## Product Update

# DENSO® Spark Plug Modifications

## Enhancement to the Material Composition

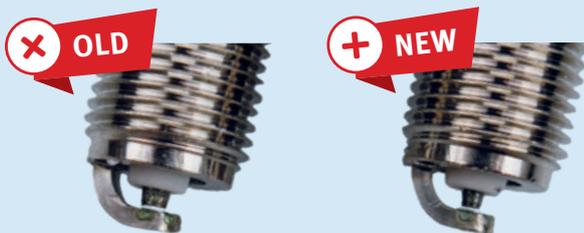
The latest improvement is a change to the material composition of the alloy used for the centre electrode chip. DENSO®'s new patented alloy allows a reduced diameter centre electrode, which results in consistent or improved operating lifetimes. The changes will also enable better management of future fluctuations in the market of precious metals.

To distinguish the new Spark Plugs from the current range, an underscore has been added to the Spark Plugs description as shown in the photo.

**The first Spark Plugs to utilize the new alloy are the GE3-5 and GK3-5 types with immediate effect.** If any of your open order is affected, you will receive a new order confirmation showing the new part numbers as following:

P/N – Old Version	P/N – New Version
GE3-5	GE3-5-267600-0250
GK3-5	GK3-5-267600-0260
